V2500-A1/A5/D5 PROPULSION SYSTEMS SERVICE BULLETIN

This document transmits the Revision 6 of Service Bulletin V2500-ENG-72-0359.

V2500-ENG-72-0359

ENGINE - LP TURBINE - INNER TRANSITION DUCT - APPLICATION OF WEAR RESISTANT COATING
TO PREVENT FRETTING

Family Tree - Support Assy Diffuser Inner
Figure 1

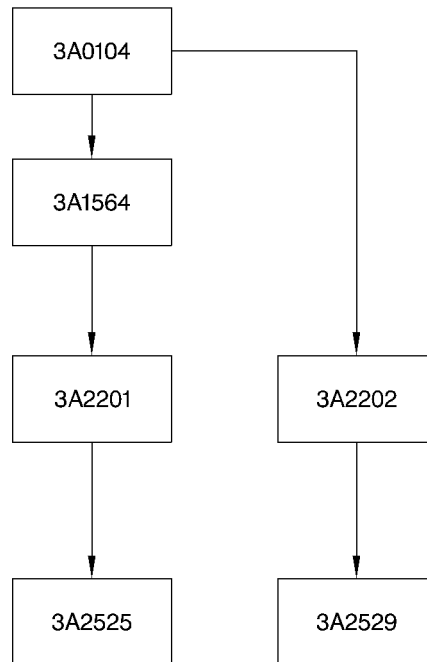
Rework existing Inner Diffuser Assy (3A2201 and/or 3A2202) (72-50-24)

SBE 72-0359
ENGINE - LP TURBINE - INNER
TRANSITION DUCT - APPLICATION
OF WEAR RESISTANT COATING
TO PREVENT FRETTING

OLD PART NUMBER	NEW PART NUMBER
3A2201	3A2525
3A2202	3A2529

Family Tree – Ring Assy Support
Figure 2

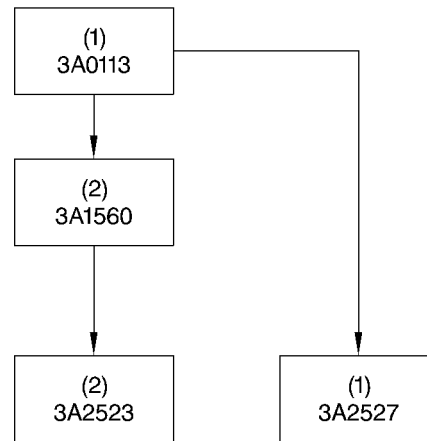
Rework existing Ring Assy Support (3A0113 and/or 3A1560) (72-50-24)

SBE 72-0359
ENGINE - LP TURBINE - INNER
TRANSITION DUCT - APPLICATION
OF WEAR RESISTANT COATING
TO PREVENT FRETTING

OLD PART NUMBER	NEW PART NUMBER
3A1560	3A2523
3A0113	3A2527
